# Access Compliance Report

Intersection ID: 32032	Main Street: COLONY_RD	Cross Street: WAKEHURST_RD	Location: NW
ADA ID: 846660CFD918	Ramp Type: PerpDiag	Initial Pass/Fail: Fail	Overall Compliance: No
		Severity Score: 22.5

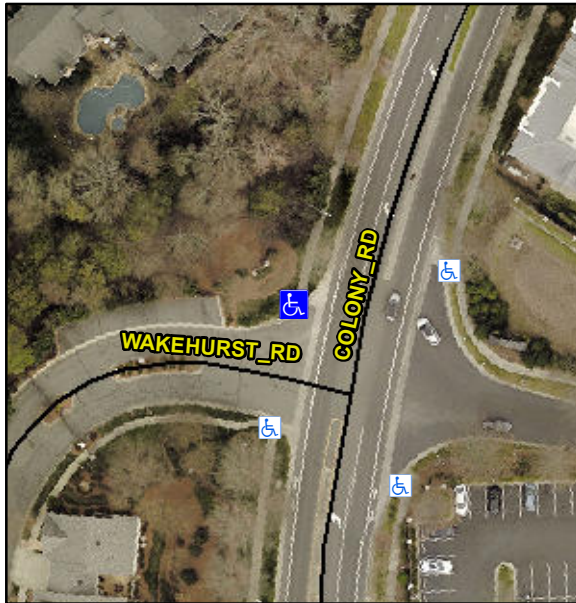
**Not Found, R304.5.1, R304.2.2, R304.5.3**

Compliance	Description	Data	Compliance	Description	Data
N/A	Ramp Length (in)	57.0	No	Ramp Slope (%)	9.3
No	Ramp Width (in)	42.0	No	Ramp XSlope (%)	2.1
N/A	Flare Type LT	N/A	N/A	Flare Type RT	N/A
N/A	Flare Slope LT (%)	N/A	N/A	Flare Slope RT (%)	N/A
N/A	Flare Traversable LT?	N/A	N/A	Flare Traversable RT?	N/A
N/A	Landing Length (in)	N/A	N/A	DWS Provided?	N/A
N/A	Landing Width (in)	N/A	N/A	DWS Contrast?	N/A
N/A	Landing Slope (%)	N/A	N/A	DWS Length (in)	N/A
N/A	Landing X Slope (%)	N/A	N/A	DWS Full Width?	N/A
N/A	Landing Curb? (Y/N)	N/A	N/A	DWS Offset (in)	N/A
N/A	Shared Landing?	N/A			
N/A	Gutter Ponding?	N/A	N/A	Gutter Slope (%)	N/A
N/A	Gutter Lip Ht (in)	N/A	N/A	Gutter X Slope (%)	N/A
N/A	Painted X Walk1?	No	N/A	Painted X Walk2?	No
	X Walk 1 Direction	To SW		X Walk 2 Direction	To E
N/A	X Walk 1 Width (in)	N/A	N/A	X Walk 2 Width (in)	N/A
	X Walk 1 Slope (%)	0.1		X Walk 2 Slope (%)	4.1
	X Walk 1 X Slope (%)	4.2		X Walk 2 X Slope (%)	0.5

**Remove & Replace Curb Ramp With Two New Directional Ramps or Equivalent.**
